City of Alexandria, Virginia

MEMORANDUM

SUBJECT: POTOMAC YARD METRORAIL STATION (2901 POTOMAC AVENUE)
CONCEPT REVIEW WORK SESSION #7

Figure 1. Map of site illustrating which elements are subject to BAR regulatory approval of a Certificate of Appropriateness.

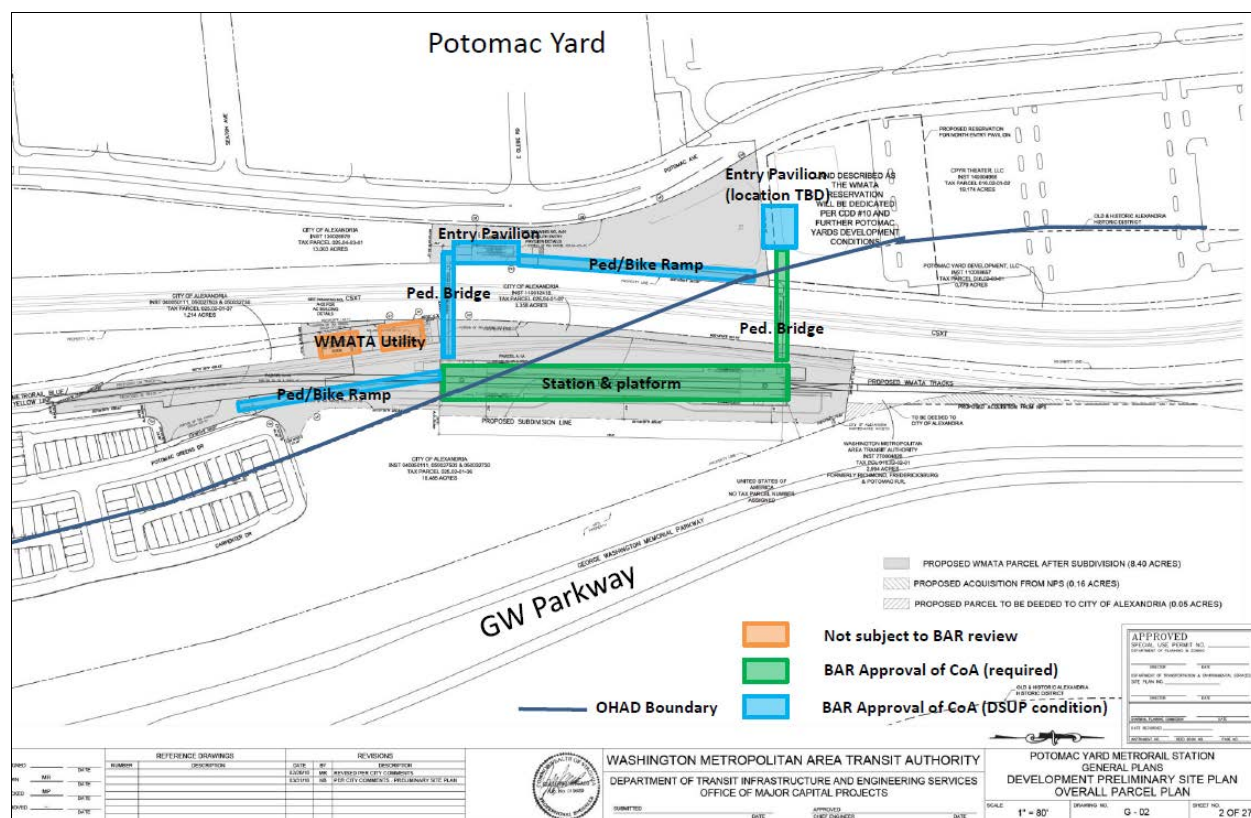
In this case, because the City is the applicant and in consideration of the location and visibility of the project, it was most logical for the BAR to review the entirety of the station and its ancillary elements as a single project rather than, for example, reviewing one pedestrian bridge but not the other. Therefore, staff will recommend a DSUP condition requiring that the entire project be subject to review and approval by the BAR whether that accessory structure falls within the boundaries of the district or not. Figure 1 below describes the BAR's review role in this case.

Figure 7. Refined truss system for the pedestrian bridges with stone piers, visually minimal diagonal chords, a curved roof and mesh walls.

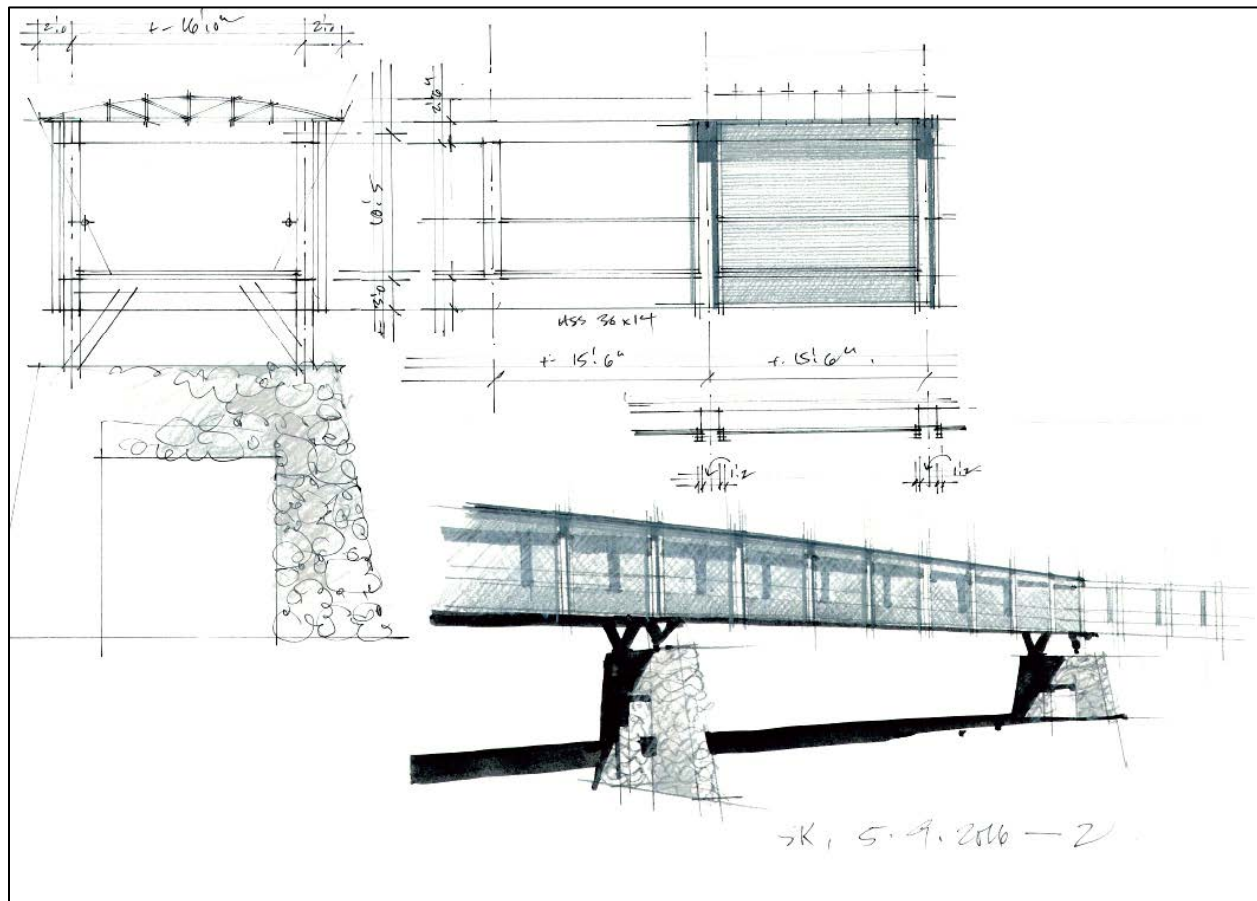
Because of the required clearance above the rail tracks and the distance across both the Metro and CSX tracks, the two pedestrian bridges are large and visually prominent but are critical support infrastructure for the station operation. At the previous work sessions, the BAR noted that the pedestrian bridges, particularly the northern one, would be very visible from the George Washington Memorial Parkway and therefore asked for further study. The Board also restated that the pedestrian bridges should relate to the architectural character of the station as a whole and should not appear as foreign appendages. The BAR had mixed opinions over which alternative to pursue, with some preferring a refined vertical truss system and others supporting the splayed arch form. The National Park Service expressed serious concern with the arch forms for the pedestrian bridge because they felt it became a significant design feature rather than a secondary, background element for the station.

Staff worked with the design team to explore the splayed wall without an arch and it was very apparent from initial study that such an approach would introduce a foreign element to the overall design. Additionally, the mix of vertical walls and segmental arches throughout the project are clear references to GWMP infrastructure whilst the splayed wall had little connection to the GWMP. Therefore, the design team continued to refine the BAR's comments regarding the truss scheme. The previous comments indicated support for this type of scheme but noted that the diagonal members should not be overbearing and the verticals should architecturally relate to the station walls. Figure 7 shows an updated rendering of the pedestrian bridge that is

visually light for the bridge portion yet grounded to the GWMP with the stone piers. Staff strongly supports this approach, as it limits the diagonal braces and makes the bridge as appear as structurally and visually light as possible. While staff recognizes that engineering needs may call for additional support, these should be as delicate as possible. As an example, cables may be used for diagonal truss chords in tension.

19. Staff recommends the refined truss pedestrian bridge option (Figure #7 above), with a low curved roof to recall the main station and that the truss system be as visually light as possible with visibly minimal diagonal chords.

20. Provide large scale sections and details of the selected pedestrian bridge option including the stone supports, the shape of the roof and supporting structure, the truss and exoskeleton, and the mesh bridge wall material(s)

21. As part of the final structural design of the pedestrian bridge the diagonal members of the truss shall be minimized to the greatest extent structurally feasible through material, size, shape and color.
